JOB TITLE:
 Russell Hotel
 Russell Sq, London

DRAWING TITLE:
 Elevation of Entrance Doors

JOB TITLE:
 Russell Hotel
 Russell Square, London

Door & Frames
GD11.01 & DG23.02

All Timbers in American Oak
All Veneers in Crown-cut random American Oak

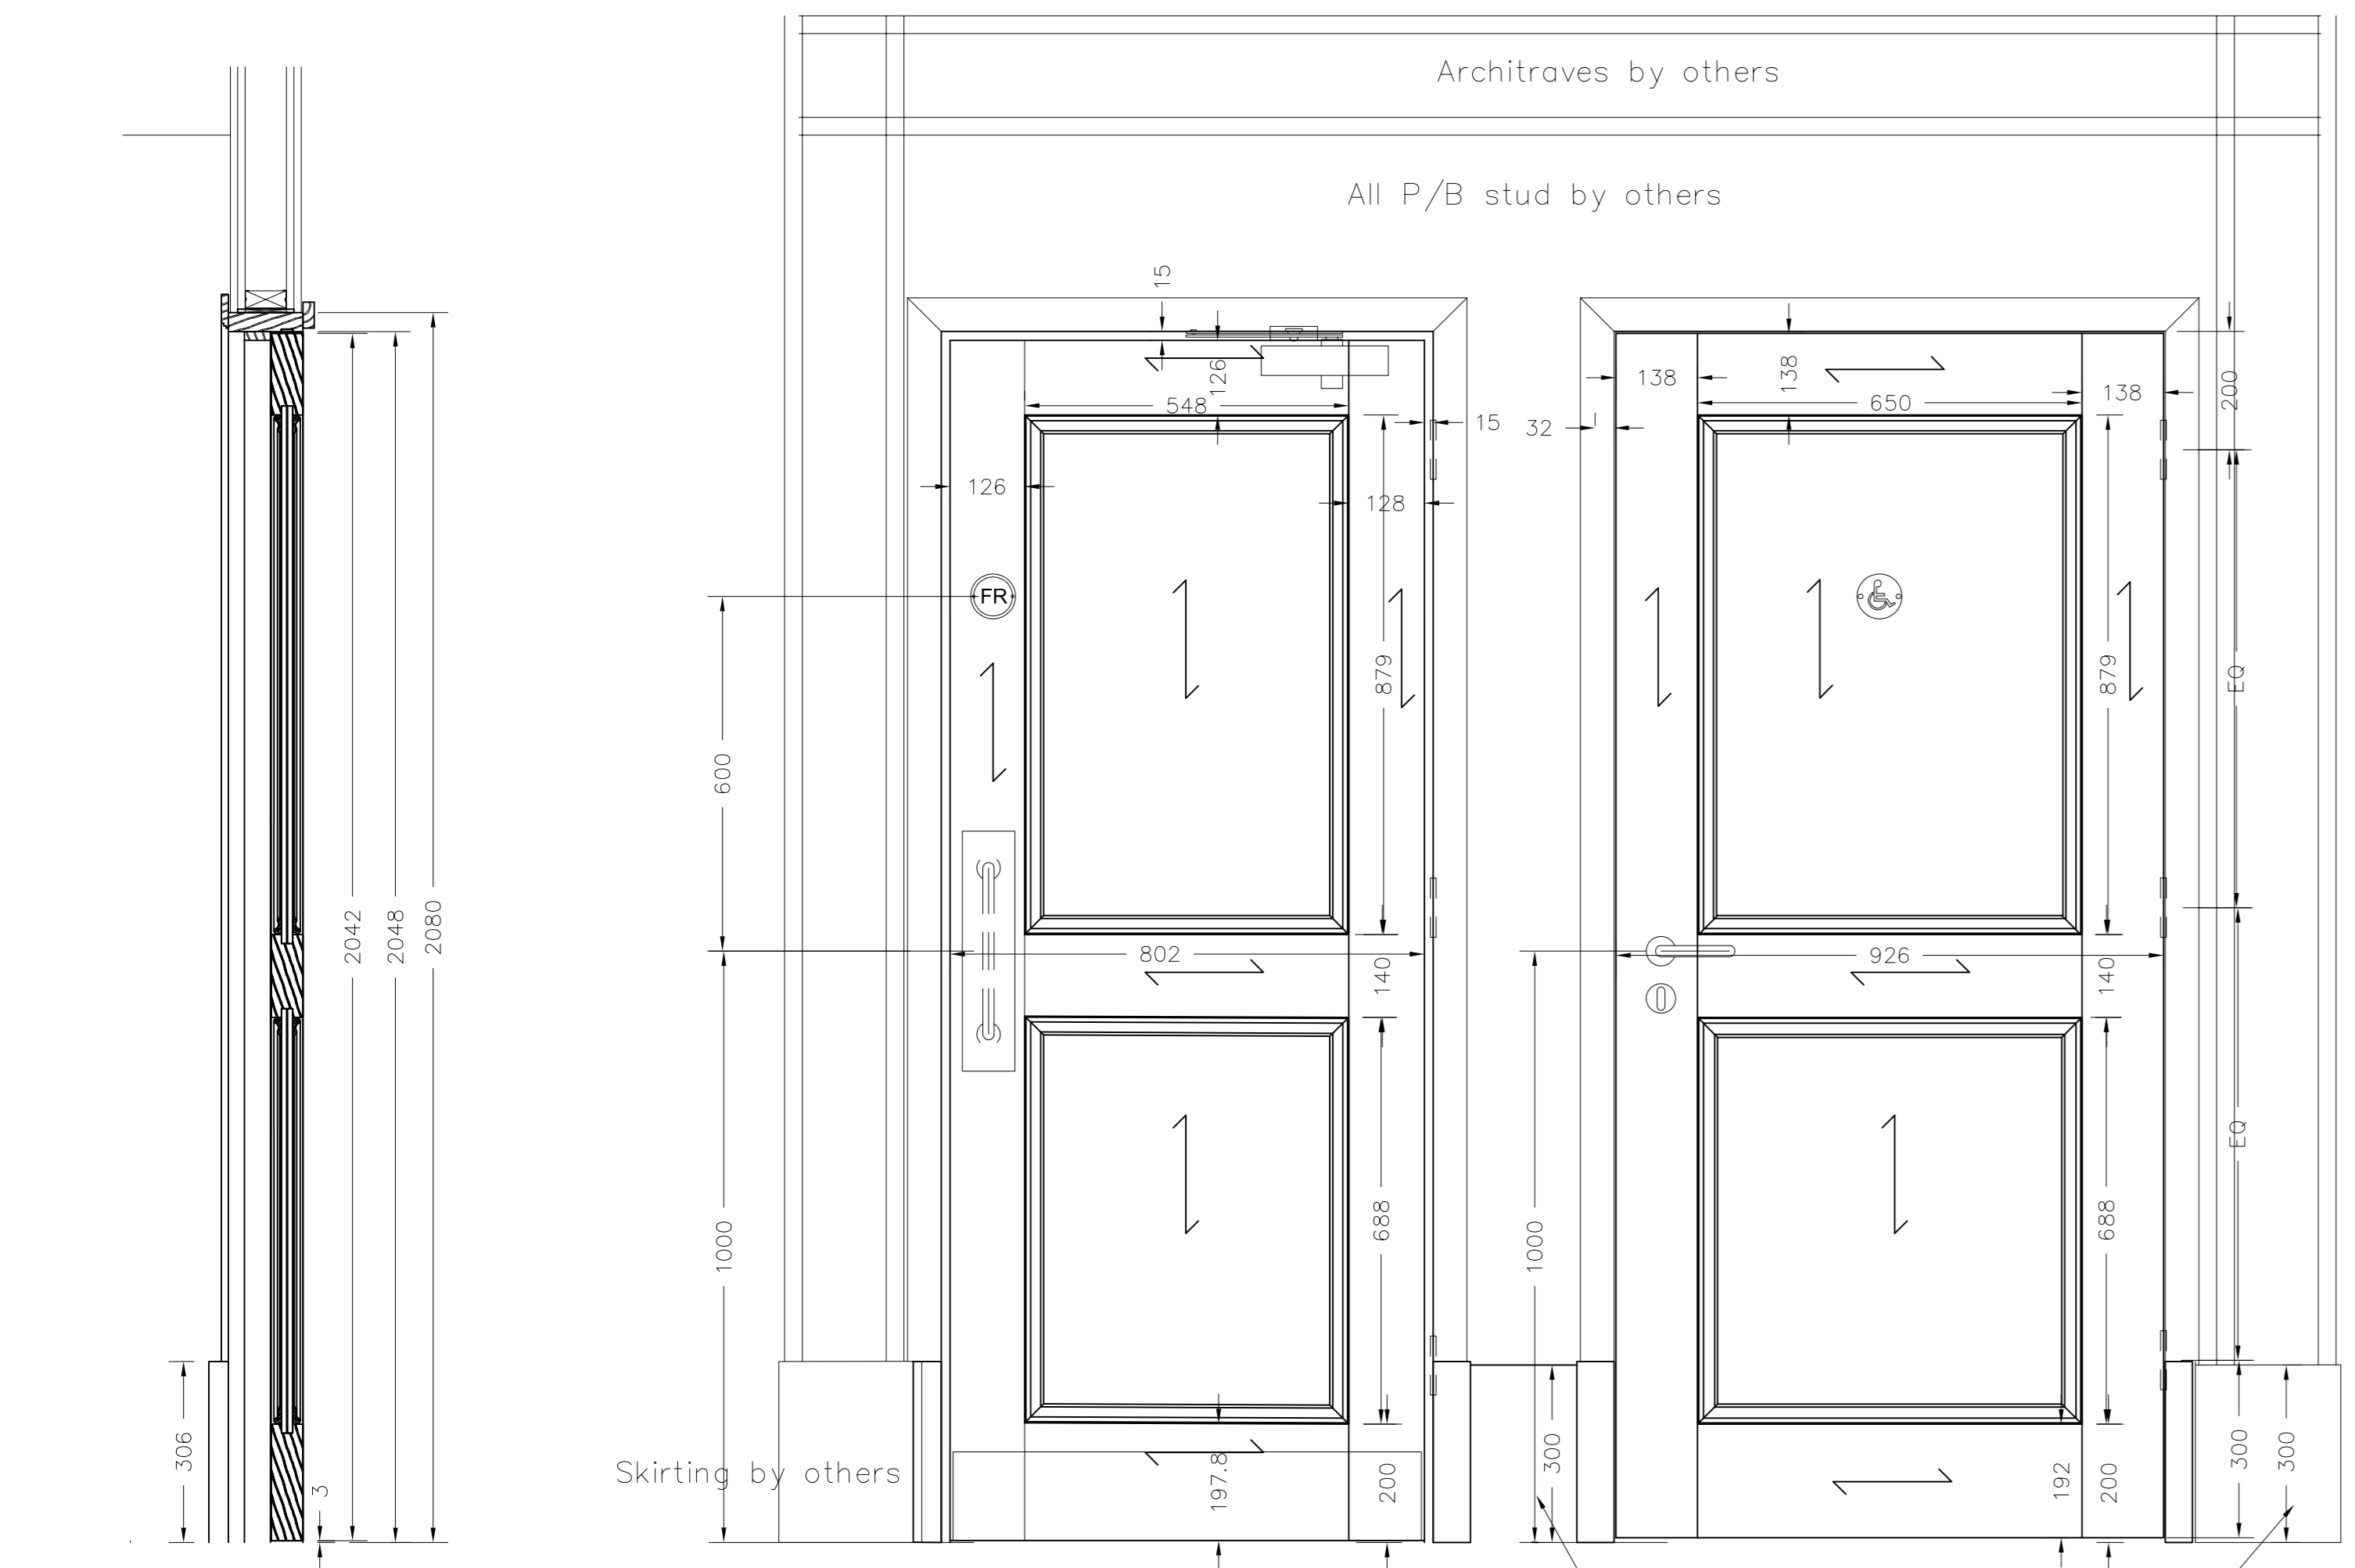
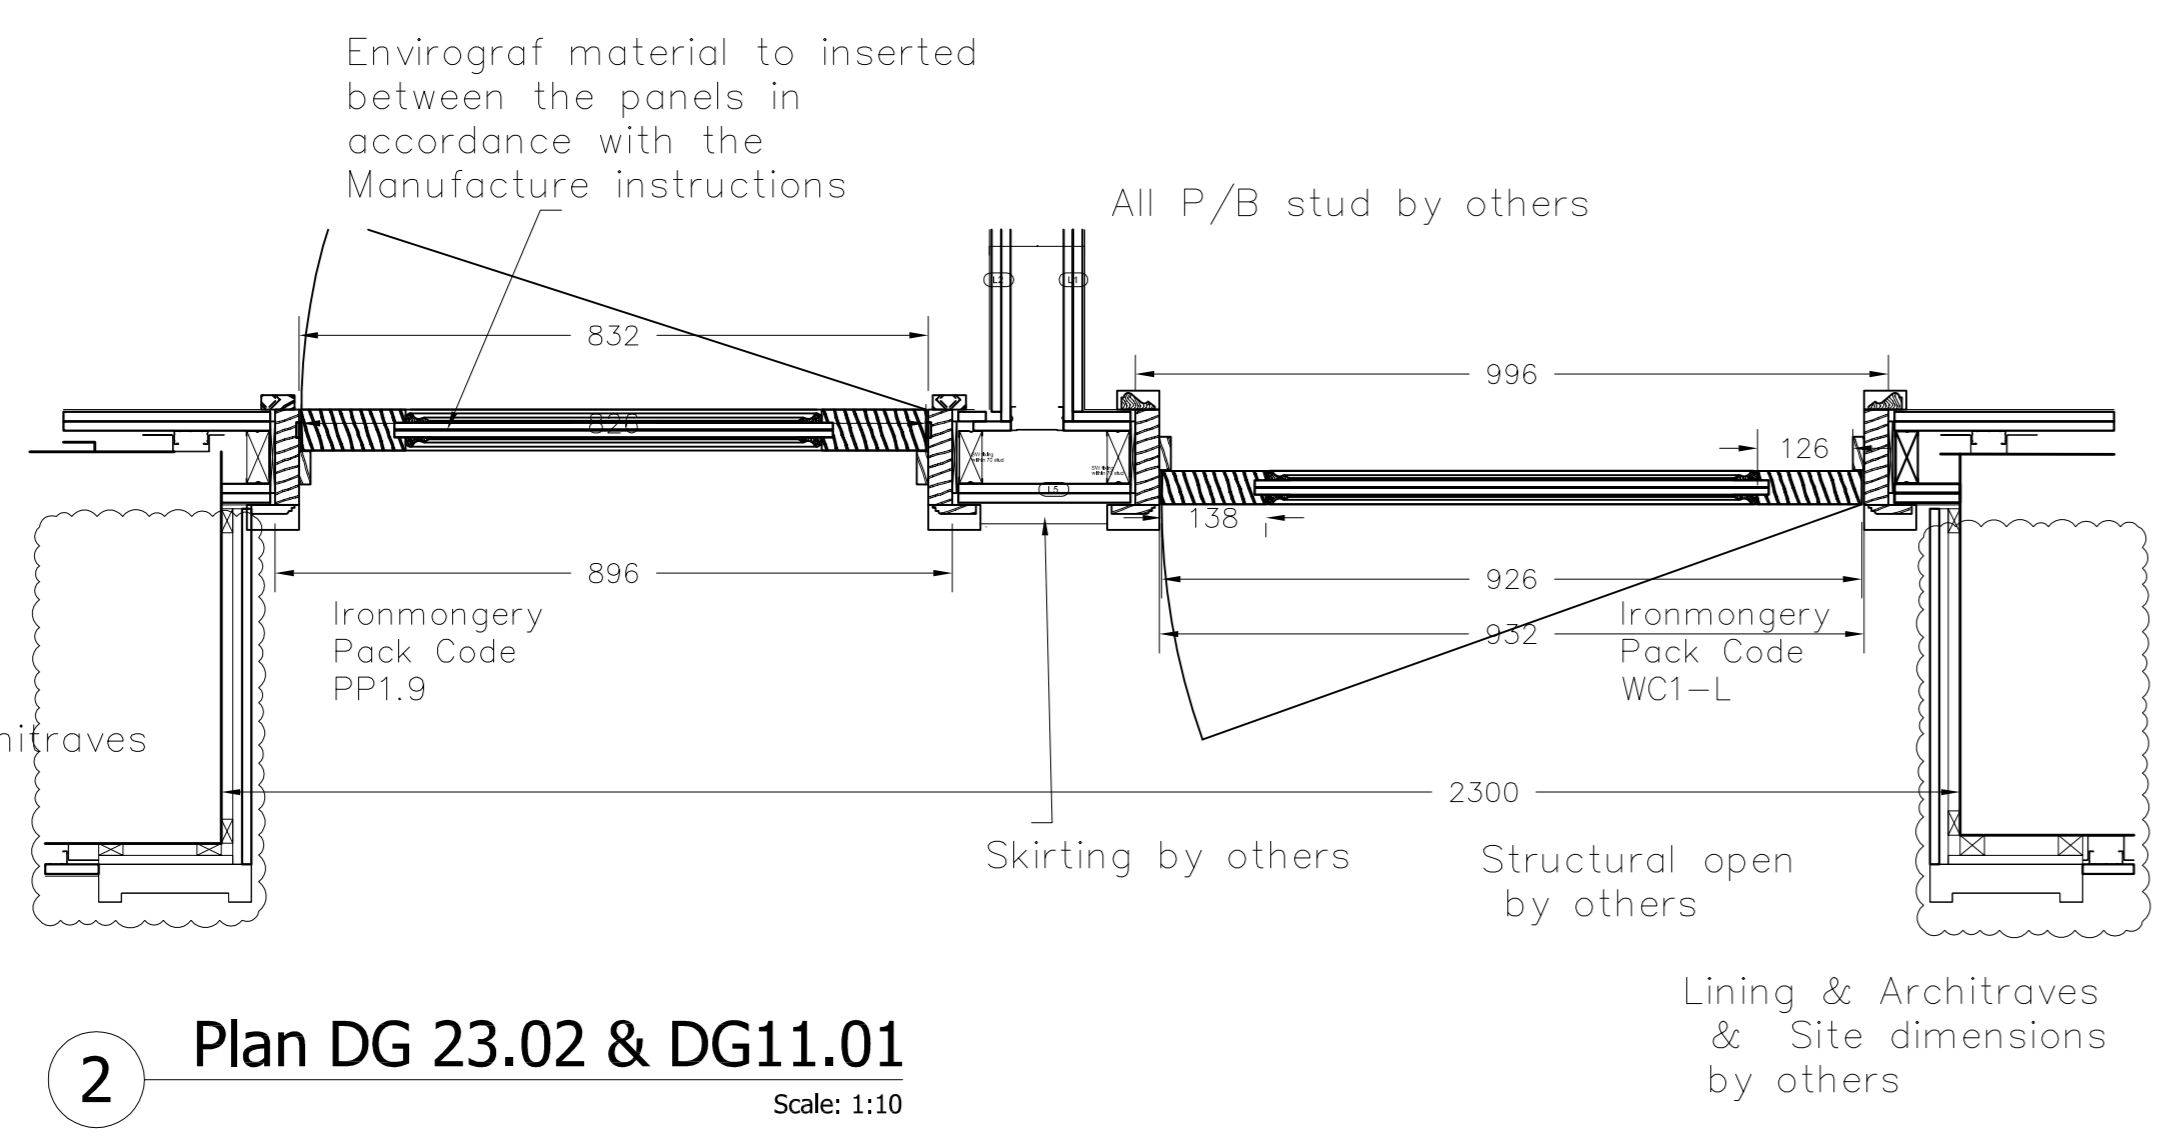
Epr Comments:
Fire spread rating all wall & ceiling surfaces to meeting Ad'B and Fusion Fire Strategy.
